UNITED STATES PATENT AND TRADEMARK OFFICE

APPLICATION NO.	FILING DATE	FIRST NAMED INVENTOR	ATTORNEY DOCKET NO.	CONFIRMATION NO.
10/761,692	01/20/2004	Chih Lung Lan	67,200-1221	3344

Office Action Summary

DETAILED ACTION

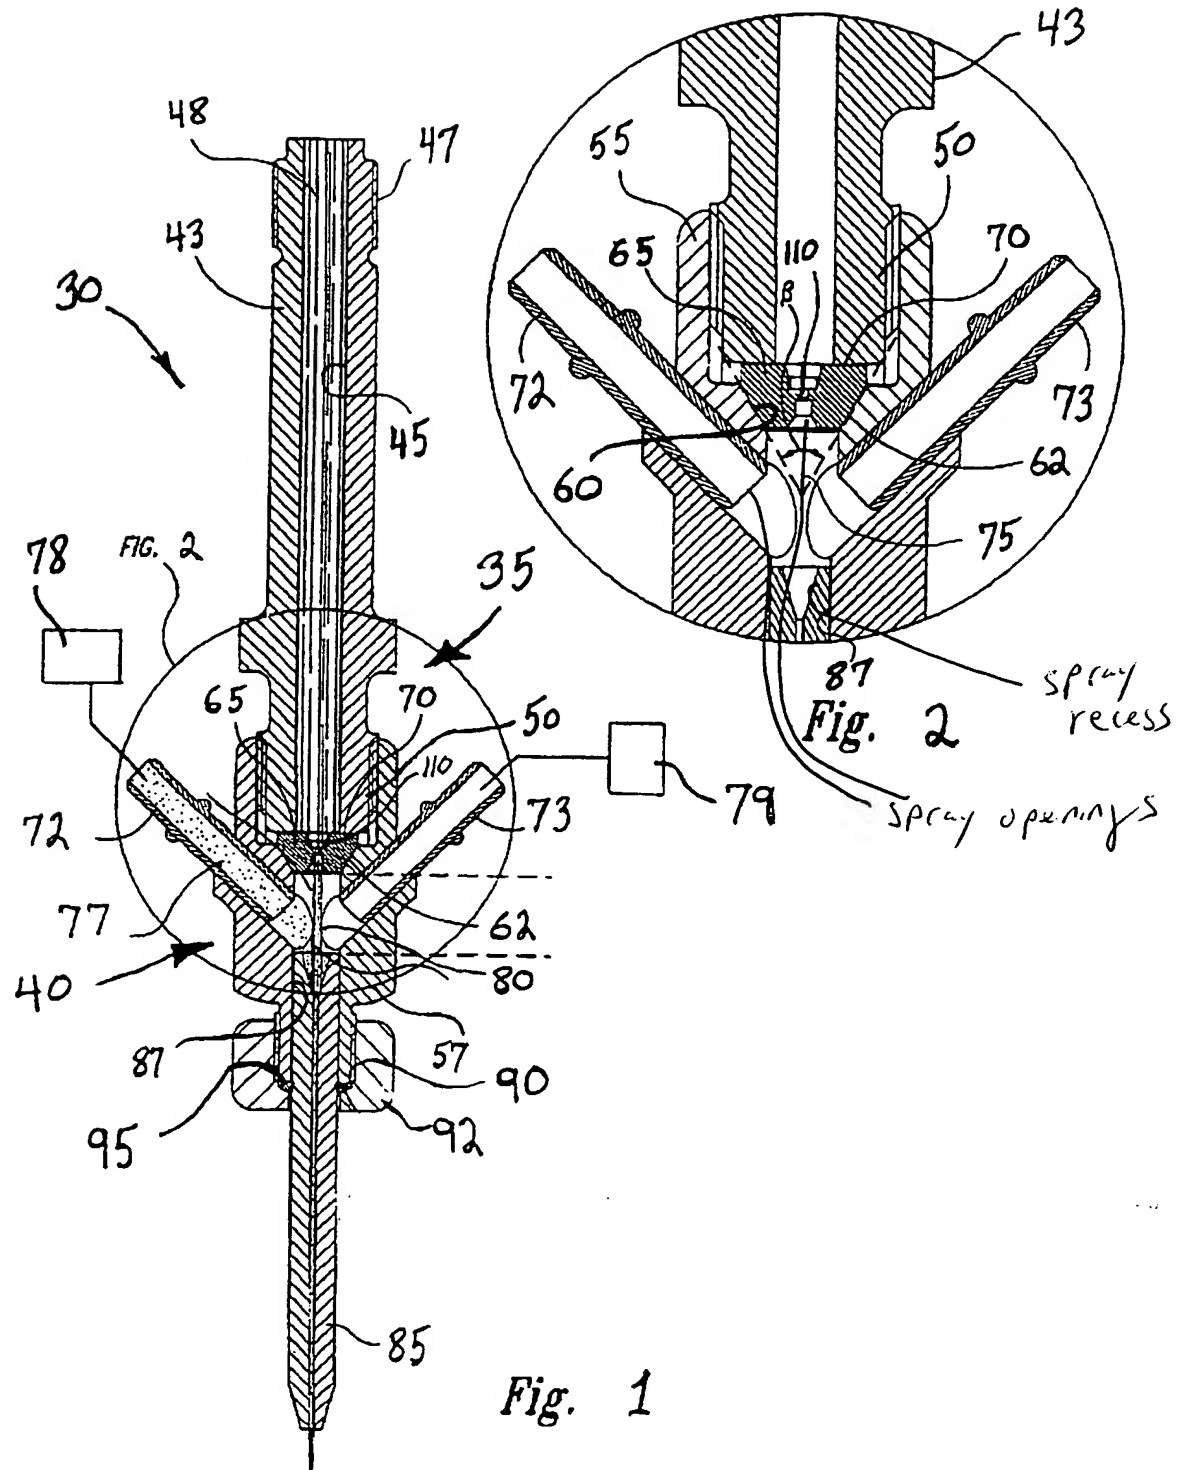
2. Claims 1-4 and 9-11 are rejected under 35 U.S.C. 102(e) as being anticipated by Julien.

Julien shows a jet cleaning nozzle comprising a nozzle body, a plurality of spray chambers 45 and 72 provided in the nozzle body, a plurality of spray openings provided in fluid communication with the plurality of spray chambers respectively, an inlet chamber 75 in the nozzle body wherein each of the spray chambers is in fluid communication with the chamber 75 as recited in claim 2, and a spray recess in the nozzle body wherein the plurality of spray openings extend between the spray chambers and the spray recess (see Figure 2 of Julien attached herein) as recited in claim 3.

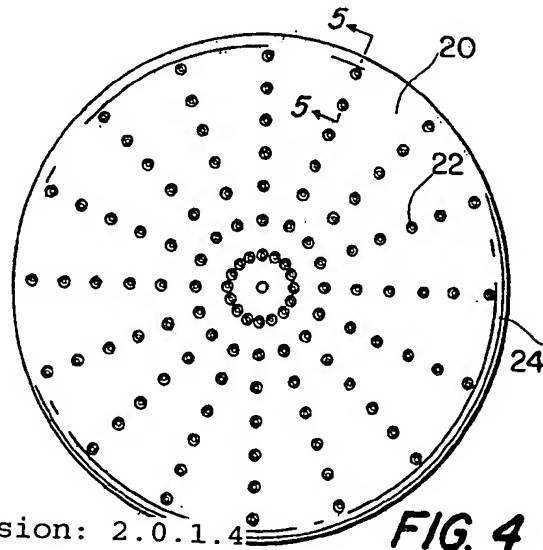
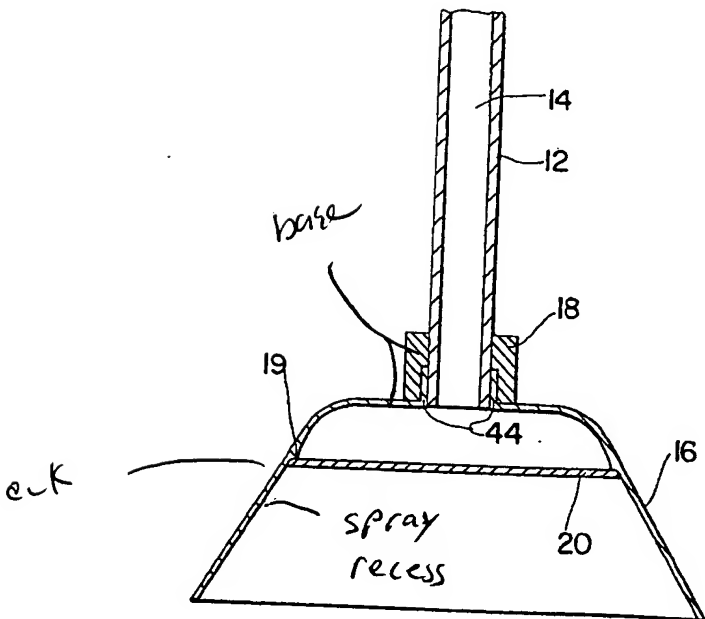
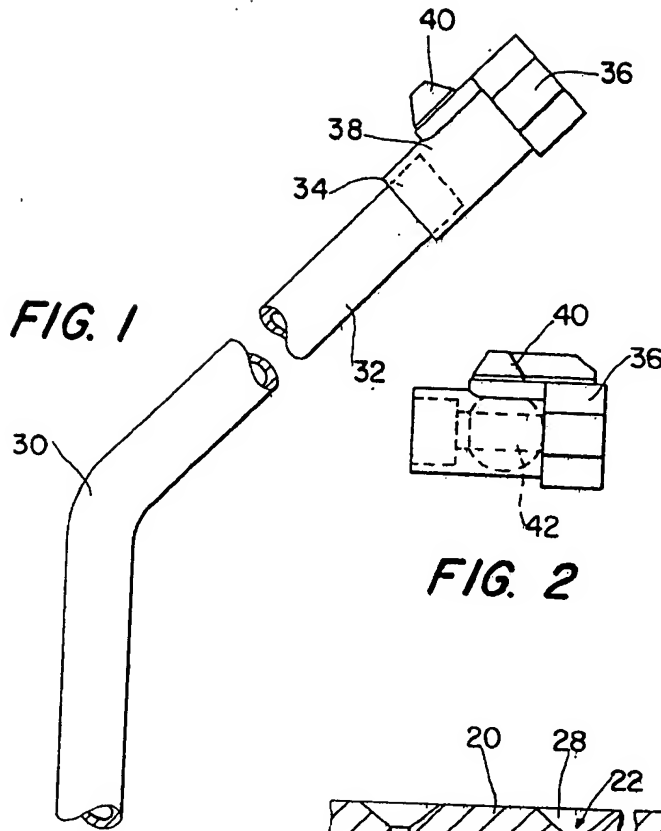
4. Claims 9, 13, 14, 17, and 18 are rejected under 35 U.S.C. 102(b) as being anticipated by Lazar.

Lazar shows a jet cleaning nozzle comprising a nozzle body having a base portion and a neck portion (see Figure 1 of Lazar attached herein), a plurality of elongated, generally cylindrical parallel spray chambers 26 in the nozzle body, a plurality of spray openings provided in fluid communication with the spray chambers, an annular, generally tapered front wall 22 in each of the spray chambers and wherein the spray openings extend through the tapered front wall in the spray chambers as recited in claim 13, and a generally circular inlet chamber 14 as recited in claim 14, and a spray recess (see Figure 1 of Lazar attached herein).
